MEMORANDUM

To: Kevin Inouye (CEAA) **Date:** 29 November 2016
From: Michal Wypych, Chief Mine Engineer
Subject: Response to Ajax Project Application/EIS Comment Number CEAA 038.1

CEAA Information Request 038.1

Figure 1. 2011 and 2015 Assessment of Alternatives pit limits.

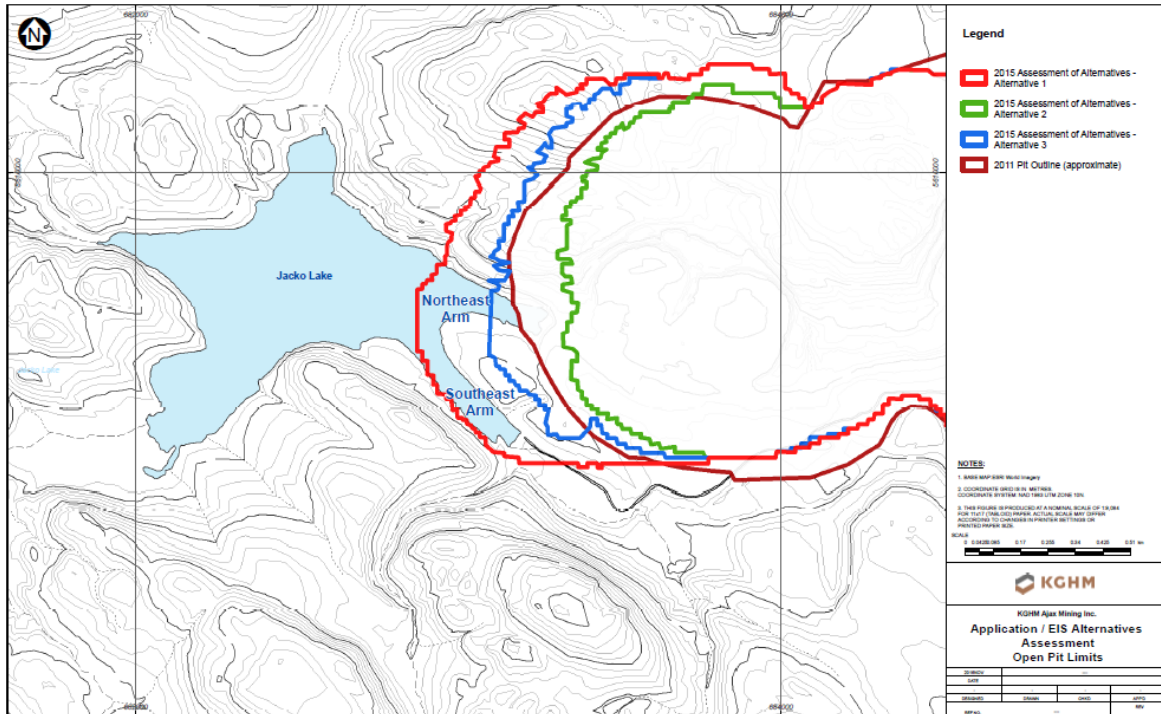
The alternatives assessment does not include consideration of the originally proposed preferred design option presented in 2011. The original design involved only a partial loss of the Mine Bay Arm (North East Arm) of Jacko Lake. When the project was revised in 2014, this option was replaced with the loss of the entire Mine Bay Arm of Jacko Lake. To support the proponent's assertion that avoidance of impacts to Jacko Lake is not possible, conduct an alternatives assessment and provide the results that include consideration of this original design with only a partial loss to the Mine Bay Arm of Jacko Lake.

The 2011 and 2015 open pit configurations are not identical. Since 2011, KAM has advanced the technical (geological, geotechnical, metallurgical, design) and economic understanding of the orebody such that the design basis has materially changed. In addition, many of the inputs to the economic model such as commodity prices, mining costs, exchange rates, etc. have changed between 2011 and 2015 that result in different feasibility thresholds. As a result of these changes and to ensure resource maximization, the 2015 pit limits have expanded from the 2011 configuration in the area between the northeast and southeast arms of Jacko Lake. To maintain continuous and realistic mining shapes, the pit limits within the northeast arm of the lake also required expansion. Nonetheless, Figure 1 shows that both the 2011 and preferred 2015 open pit limits partially enter the northeast arm of Jacko Lake. Perhaps most important, the 2011 open pit configuration did not include the design of a dam required to provide the geotechnical offset between the lake and the open pit for stability. This dam design if included would result in additional encroachment into mine bay of Jacko Lake.

Subsequent to the 2011 general arrangement, KAM has taken steps to optimize the Project with respect to safety, Aboriginal, public, environmental, and economic considerations through trade-off studies and most recently a Basic Engineering phase, completed in 2015. The addition of a dam to the northeast arm of Jacko Lake (JLD2 in Figure 2) is another reason that the northeast arm of Jacko Lake is further impacted in the 2015 design relative to the 2011 design. The addition of JLD2 (one of four dams proposed for Jacko Lake) was required to ensure safe operations of the open pit by containing anticipated probable maximum precipitation within Jacko Lake during extreme storm events. JLD2 requires an appropriate geotechnical stability offset² from the pit limits which was informed through the work completed since 2011. As a result, any pit limit alternative which enters the northeast arm of Jacko Lake will require a structure to control storm events such that open pit operations can be conducted in a safe manner as required by the BC *Mines Act* and the Health, Safety and Reclamation Code for Mines in British Columbia. Therefore, KAM is of the opinion that any open pit configuration which does not completely avoid Jacko Lake will require removing most of the lake's northeast arm.

As outlined in Section 17.4.6, and in our initial response to IR# CEEA-038, Alternative 3 was selected as the preferred alternative. This alternative has extents of the open pit limits relatively close to those presented in the 2011 Project Description.
